## INJECTION WELL PERMIT APPLICATION

Well Name and Number: 95620 API No: 05-075-08391  
UIC Facility No: 150330 (as assigned on an approved Form 31)  
Project Name: Emerald Unit Operator Name: Western Operating Company  
Field Name and Number: Emerald 20750 County: Logan  
QtrQtr: NWSW Sec: 35 Twp: 9N Range: 54W Meridian: 6th

# Emerald 2-35 NWSW Sec 35-9N-54W Logan Co., CO

**From:** Bob Koehler - DNR [<mailto:bob.koehler@state.co.us>]  
**Sent:** Thursday, January 08, 2015 4:35 PM  
**To:** Scott Stapp  
**Subject:** Western Operating: Emerald 2-35 (075-08391) Form 33 and Form 5A Data

## Existing Wellbore

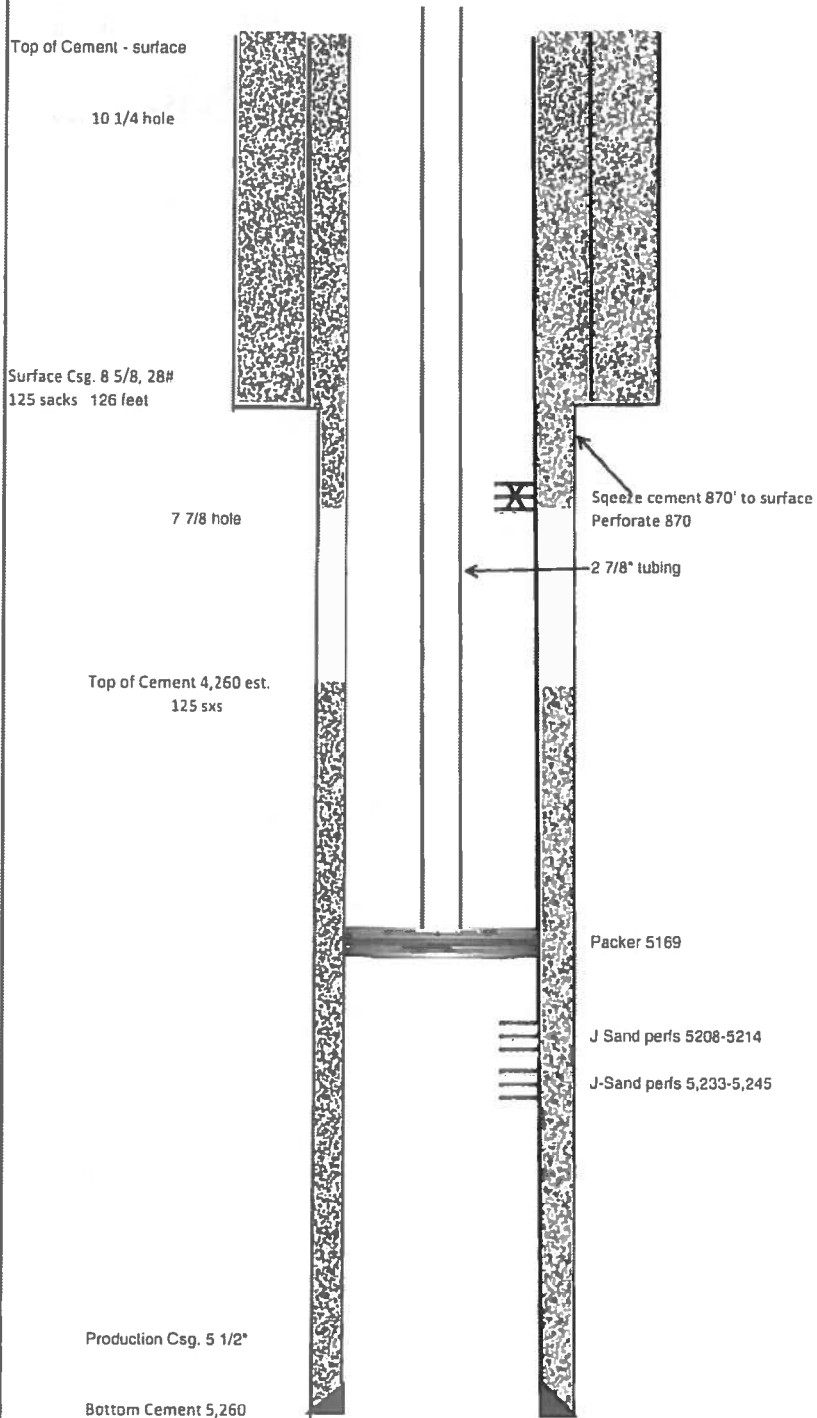
Also send a CURRENT WELLBORE DIAGRAM. This should reflect the current injection configuration you tested with the MIT.

I have attached an edited form 33 with the omitted wellbore diagram. I tried to correct the form 5A online and was unable to make any changes, so the answers to your questions are as follows:
